MODEL/DERIVATIVE:
MGF

Bull. N°: 0002
CDS. ref: M7102bu
Issue: 1
Date: 26.11.97

PROBLEM:
WATER ENTRY INTO FOOTWELL - AIR BOX

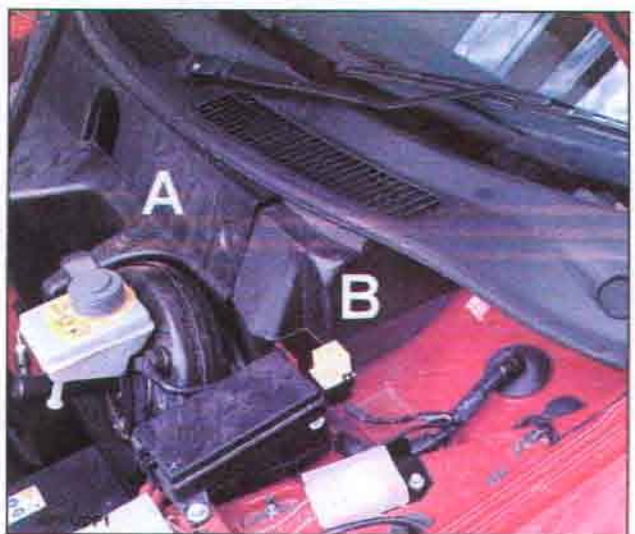
Water enters vehicle following heavy rain. Water entry may be more pronounced if vehicle is parked on an incline.

CAUSE:
Heater and ventilating air intake box conditions:

- Mounting seal allowing water through
- Insufficient air box drain holes

ACTION:
All above problems have been resolved with the introduction of a modified air box from Vin 23992. This part is now available and can be fitted to earlier vehicles.

1. From under bonnet undo the 2 nuts and single plastic stud securing the plastic bulkhead cover ('A' in photo), then remove cover to allow access to airbox ('B').
2. Slacken only, the 2 outboard servo bracket bolts and remove the 2 inboard bolts. Lift servo out of slotted outboard locations and pull forward slightly for access.
